## T10/07-094 revision 0

Date: March 01, 2007

Subject: SAS-2:UML changes for logical phys

**Figure 1 — Phy class diagram**

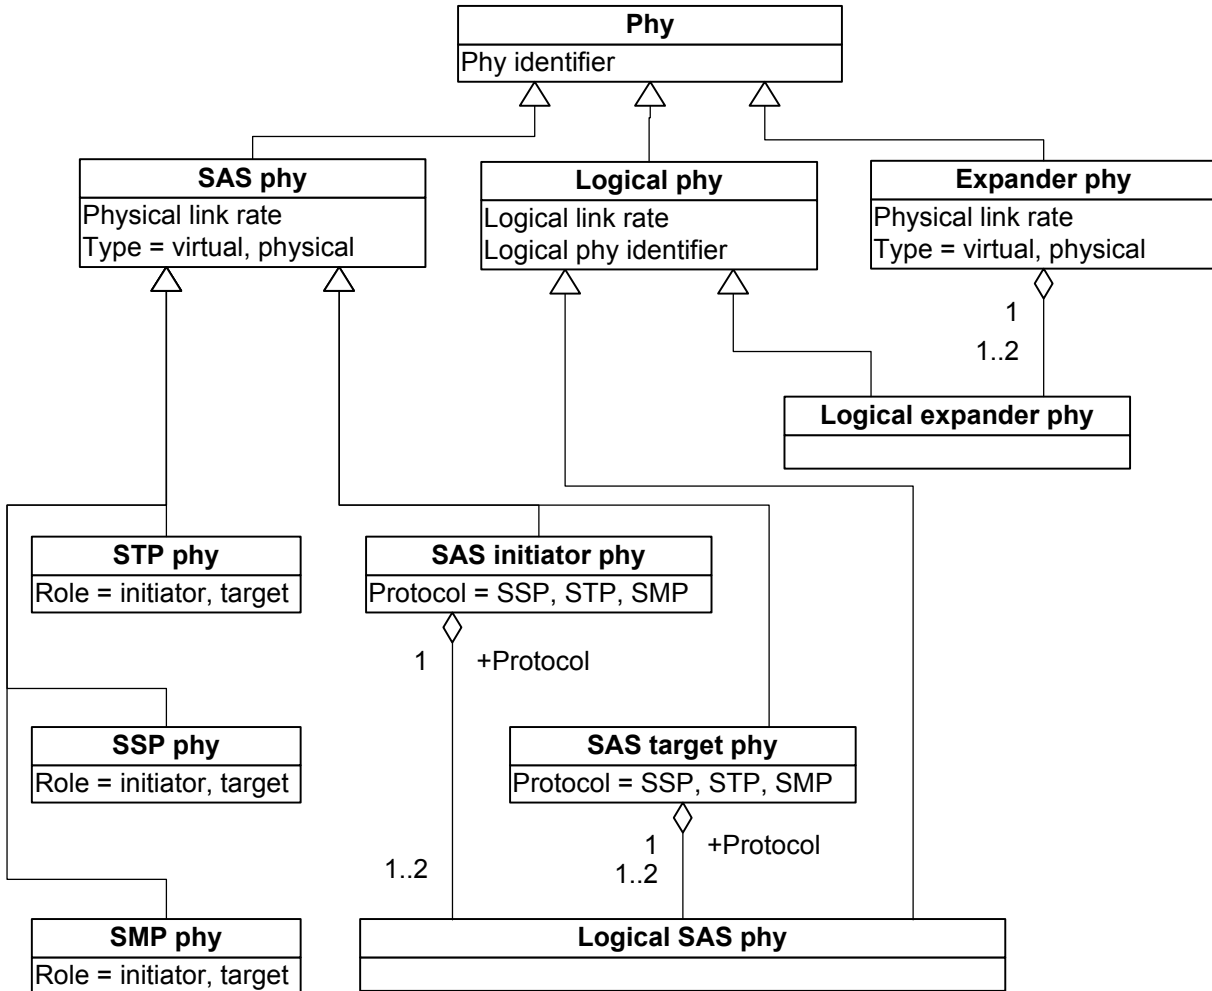
- | When logical phys were added as a result of the multiplexing proposal the phy UML diagrams for the new logical phy class and logical expander phy class were not updated. This proposal recommends changes to the phy UML diagram that for those new classes.

Figure 1 defines the phy classes, showing the relationships between the following classes:

- | a) phy;
  - | b) SAS phy;
  - | c) logical phy;
  - | d) expander phy;
  - | e) logical SAS phy;
  - | f) logical expander phy;
  - | g) SAS initiator phy;
  - | h) SAS target phy;
  - | i) SSP phy;
  - | j) STP phy; and
  - | k) SMP phy.
- | SATA phys are also referenced in this standard but are defined by SATA (see ATA/ATAPI-7 V3).

Figure 2 — SAS phy object and logical SAS phy object diagram

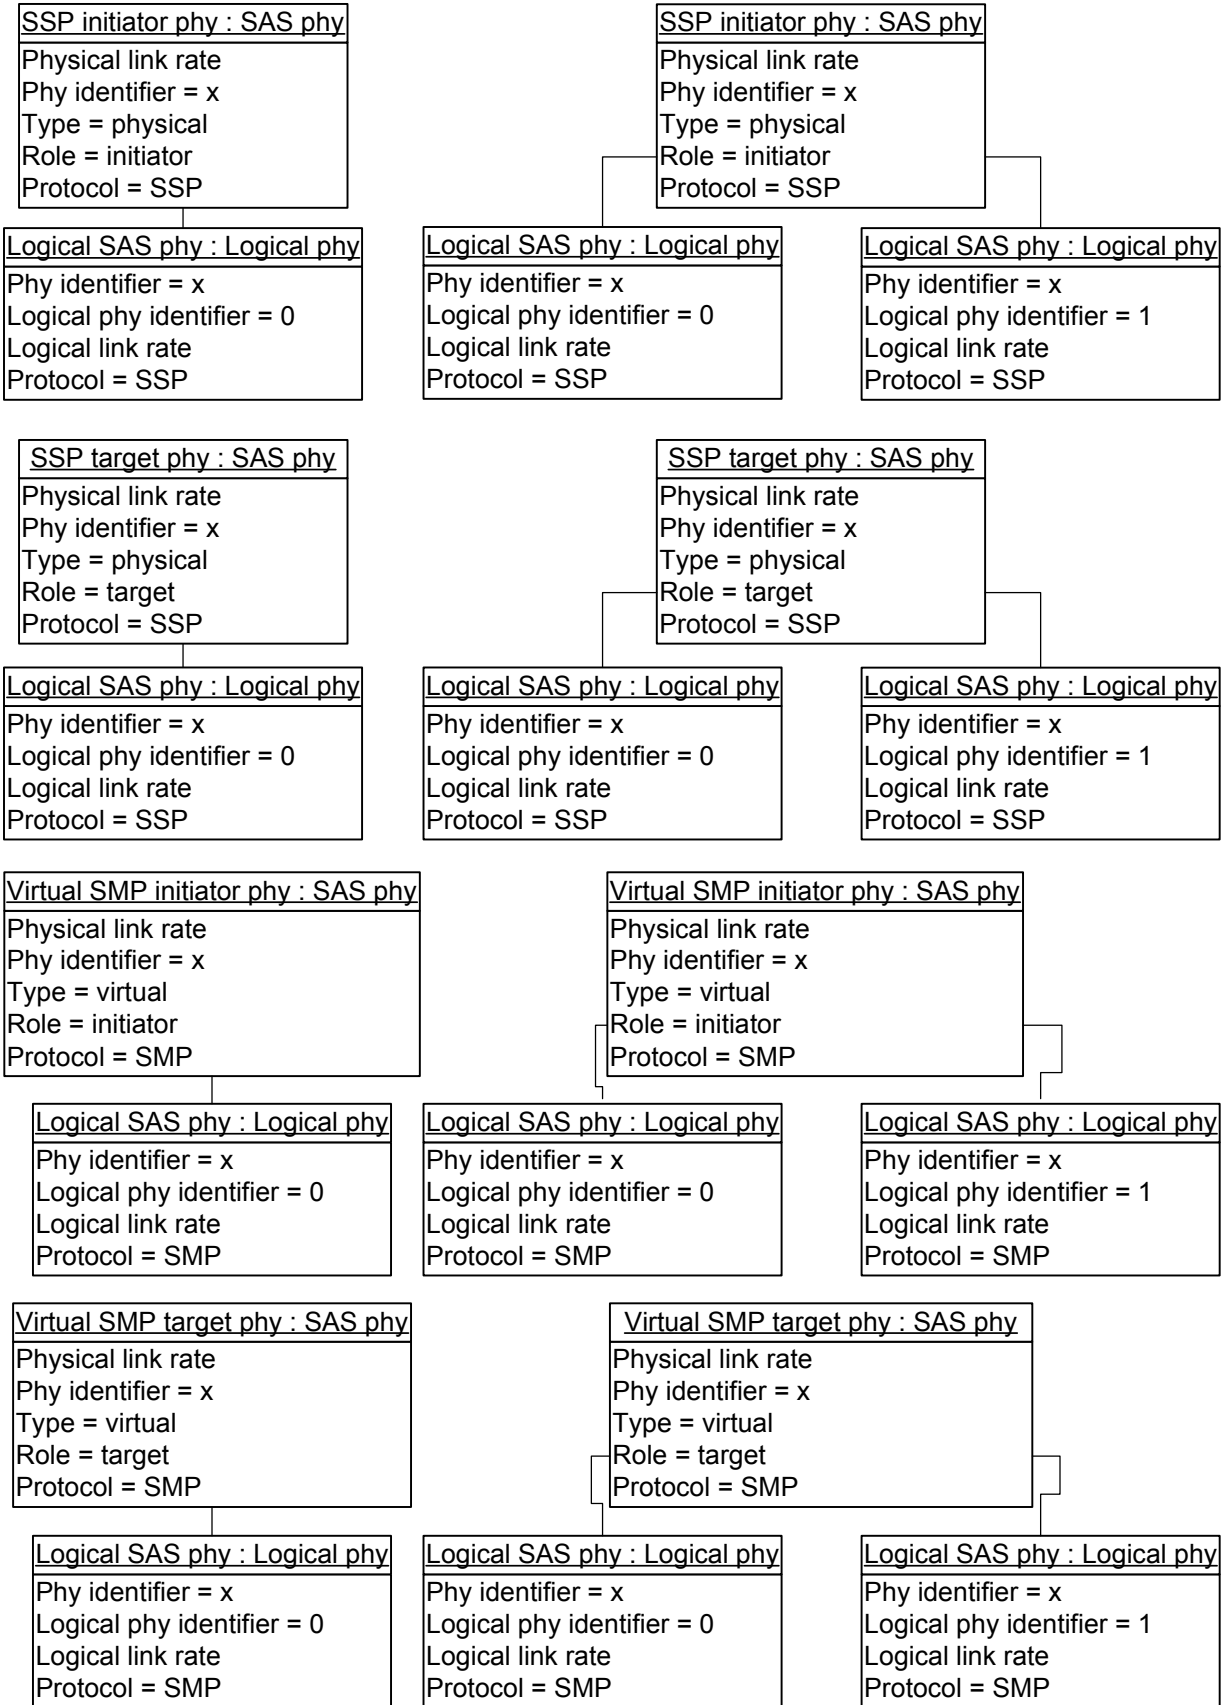
Figure 2 shows the examples objects instantiated from the SAS phy class and the logical phy class, including:

- a) SSP initiator phy;
- b) SSP target phy,
- c) virtual SMP initiator phy;
- d) virtual SMP target phy; and
- e) logical SAS phy.

A SAS phy and logical SAS phy is represented by one of these objects during each connection. A SAS phy and a logical SAS phy may be represented by different SAS phy objects and logical SAS phy objects in different connections.

Figure 3 — Expander phy object diagram

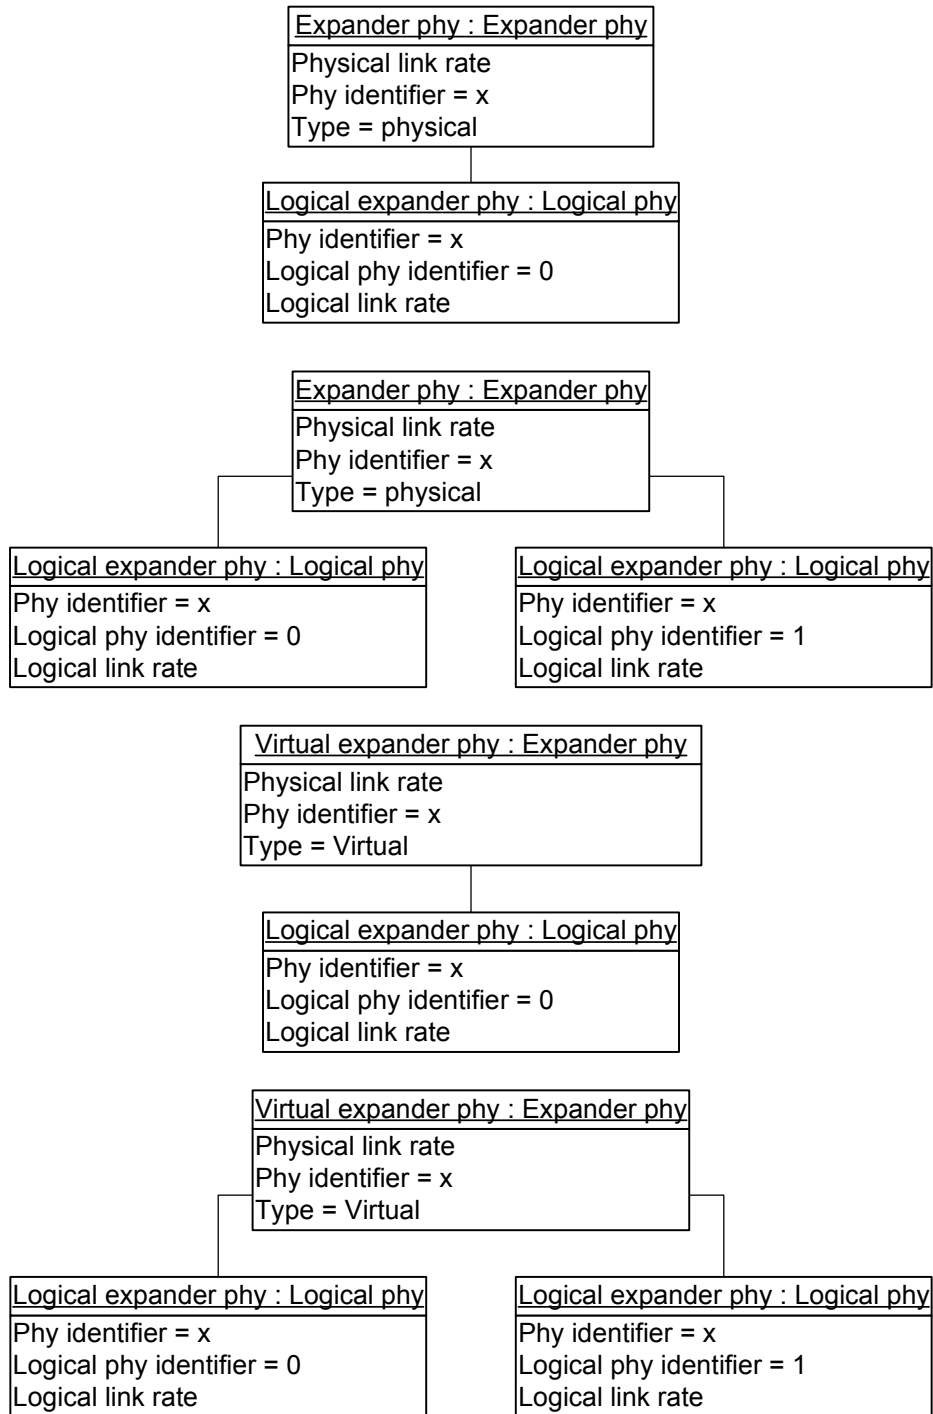
Figure 3 shows the objects instantiated from the expander phy class and the logical phy class, including:

- a) expander phy;
- b) virtual expander phy; and
- c) logical expander phy.

An expander phy and logical expander phy is represented by one of these objects during each connection. An expander phy and a logical expander phy may be represented by different expander phy objects and logical expander objects in different connections.
